CITY OF ALBUQUERQUE

December 31, 2020

RE: Sunset Farms / Puesta Del Sol Subdivision
231 Anna Maria Pl. SW
Grading and Drainage Plan
Engineer's Stamp Date: 12/16/20
Hydrology File: K12D025

MICHAEL SANCHEZ LOT 9A - GRADING & DRAINAGE PLAN

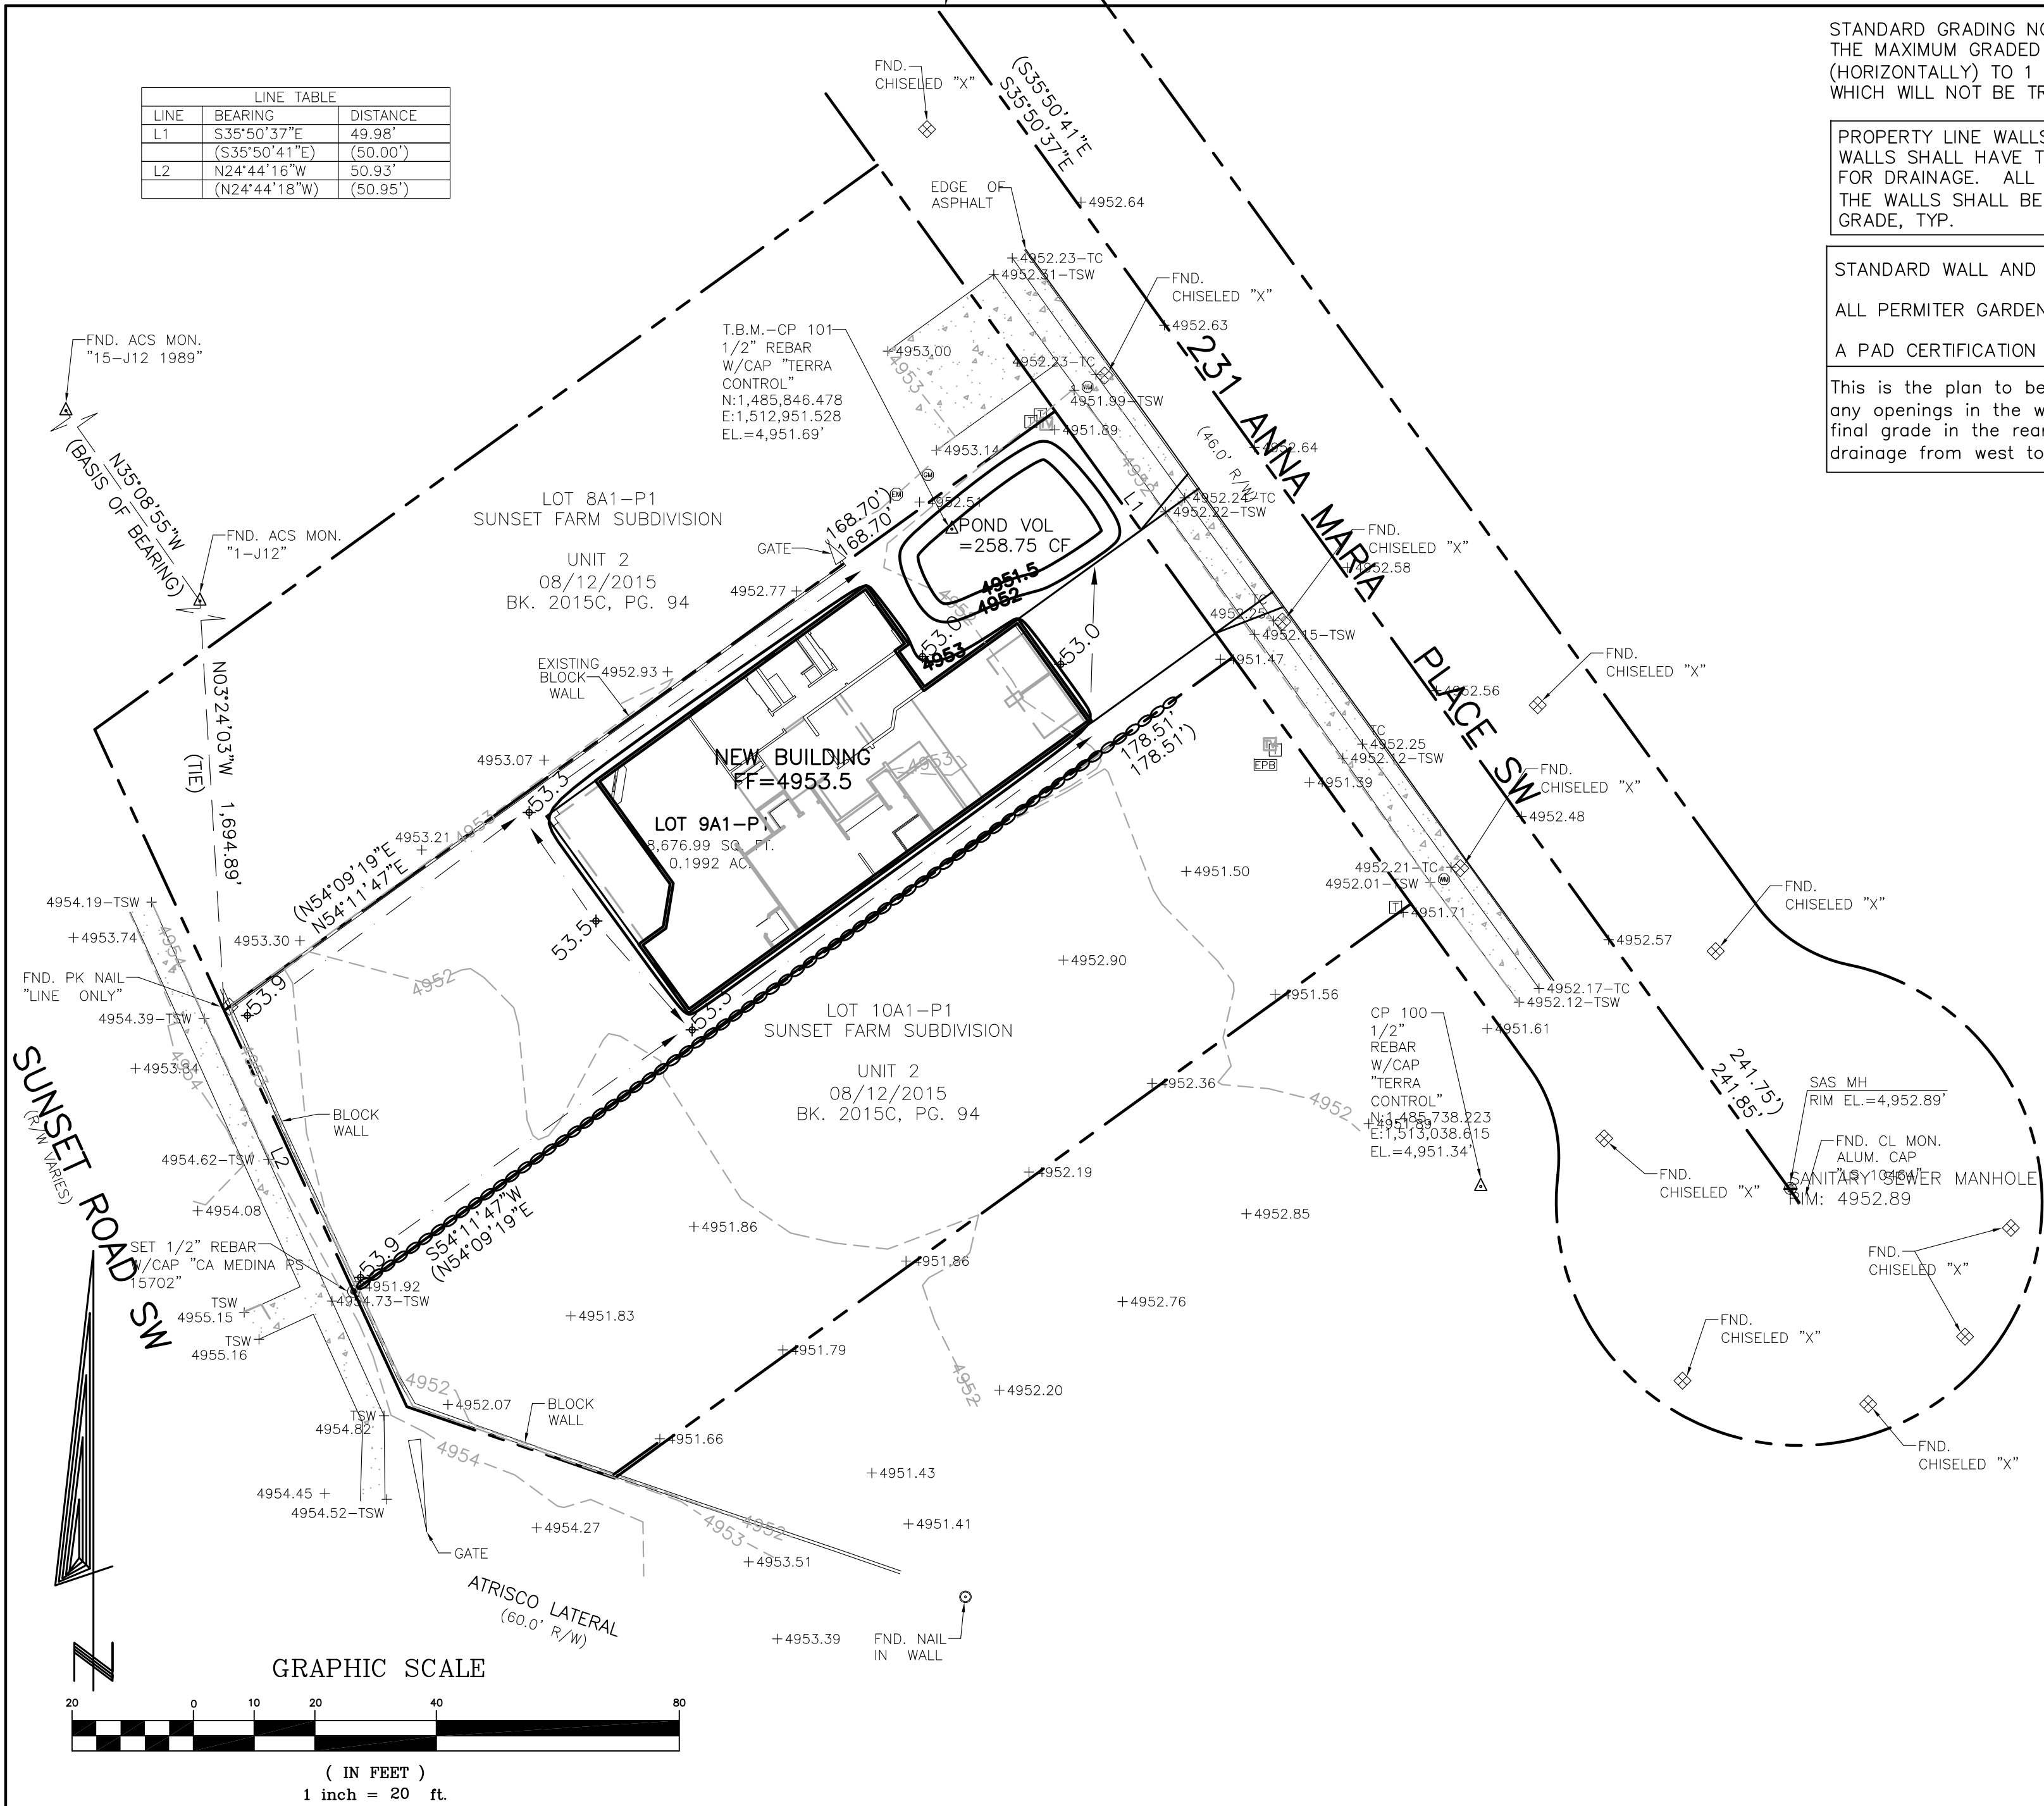
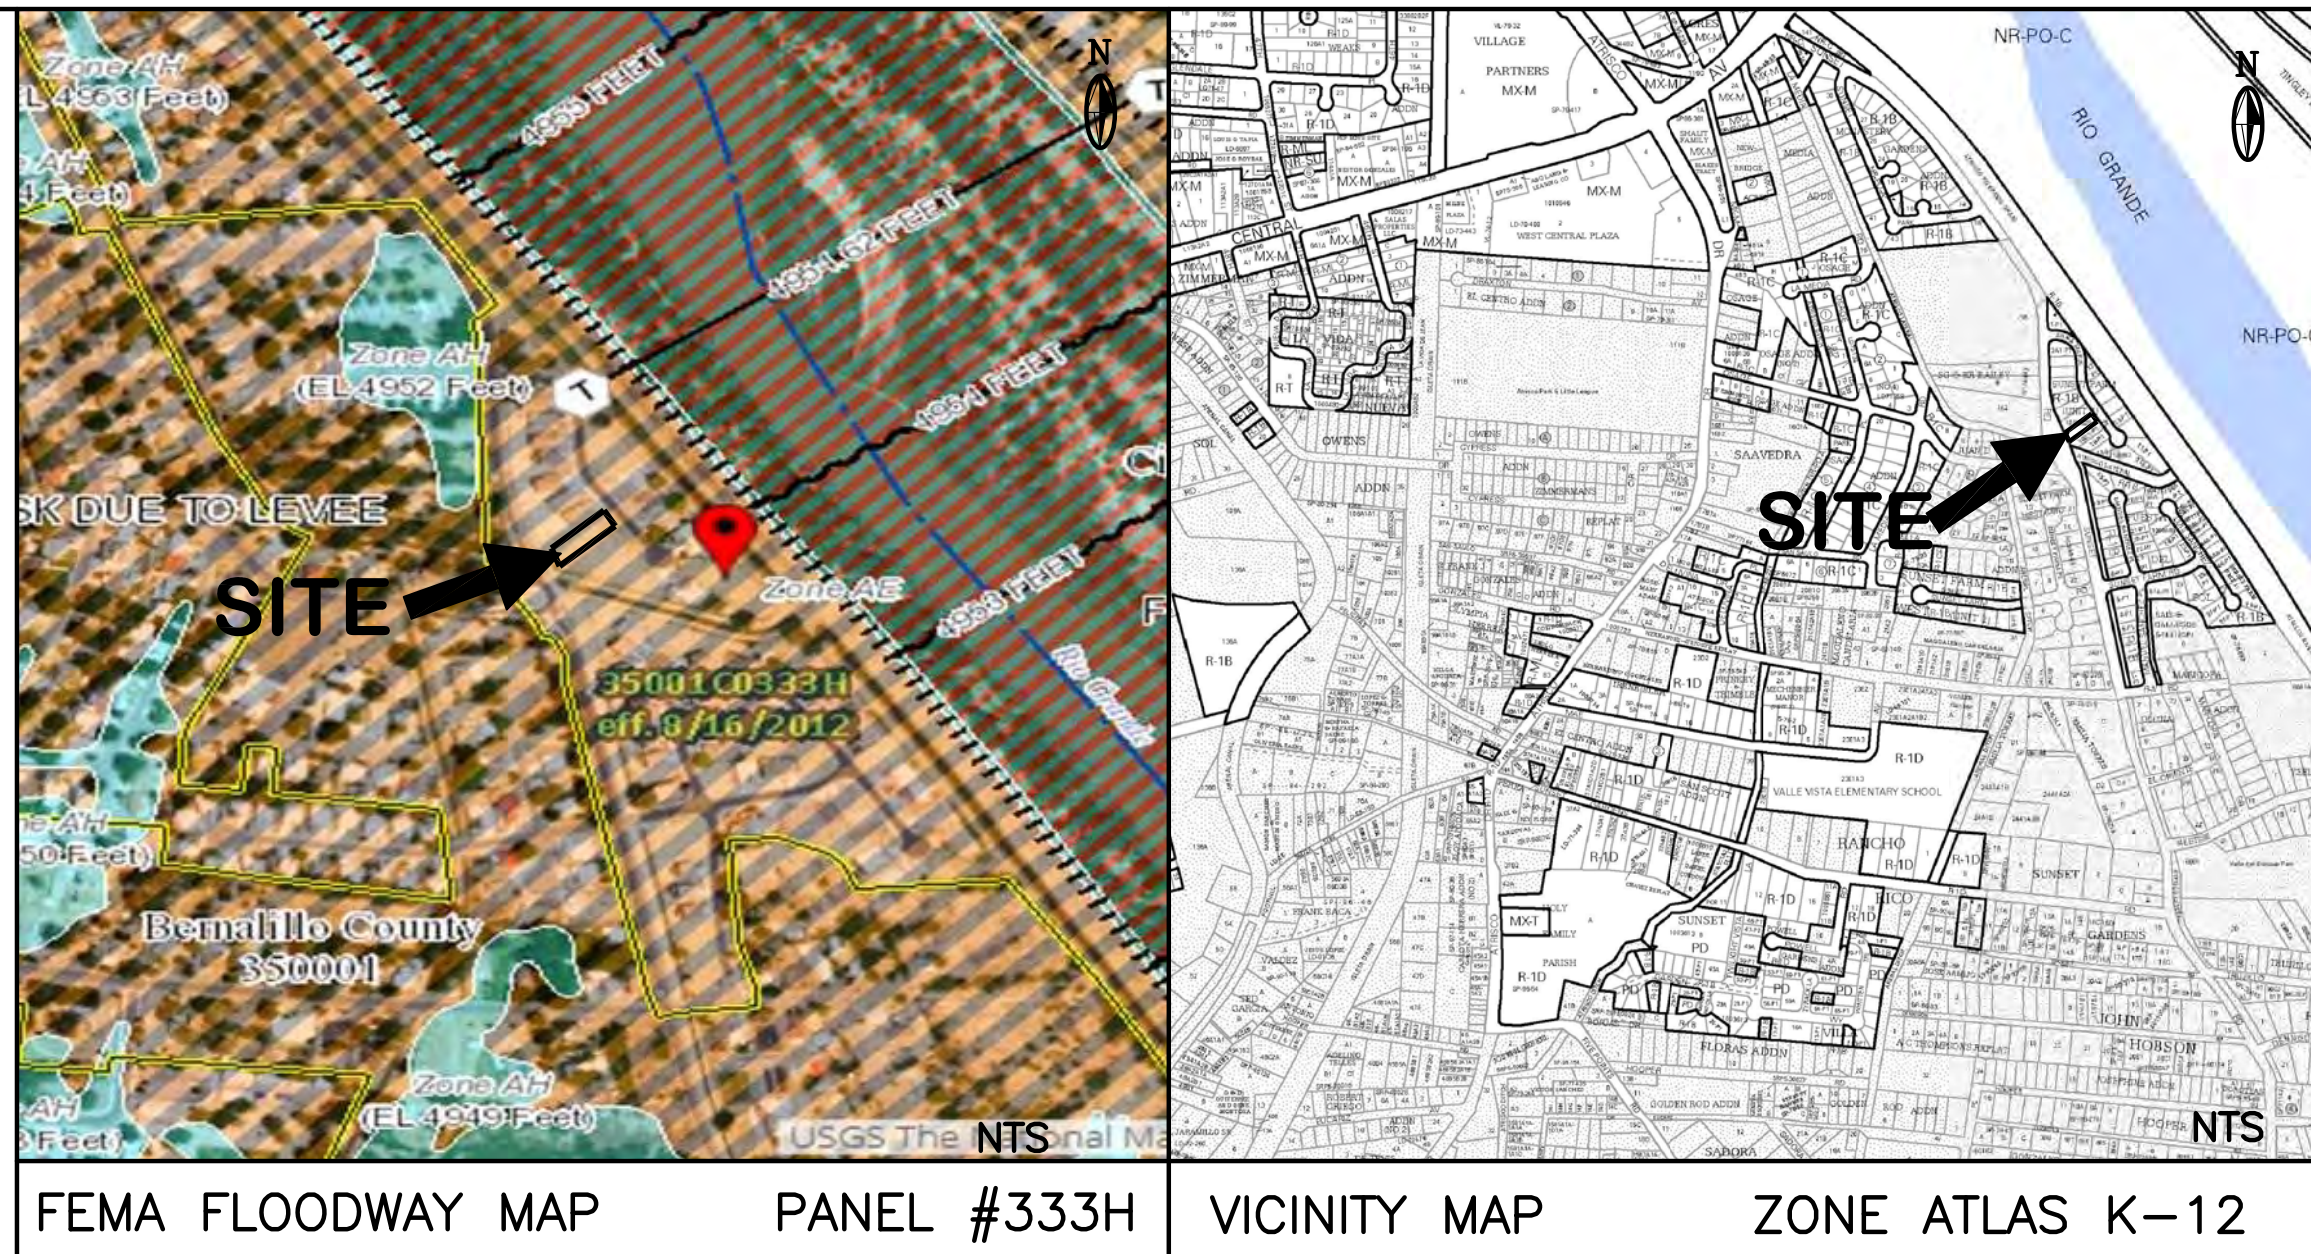
Based upon the information provided in your submittal received 12/16/2020, the Grading and Drainage Plan is approved for Grading Permit (earthwork can get started for the earth pad on the house and the retention pond work).

Once the grading is complete, a pad certification (meaning that the earthwork is complete) will be required prior to release from Hydrology during the Building Permit process. Also, at the time of pad certification approval, Hydrology will concurrently approve the Grading & Drainage Plan for Building Permit.

Prior to approval in support of Permanent Release of Occupancy by Hydrology, Engineer Certification per the DPM checklist will be required.
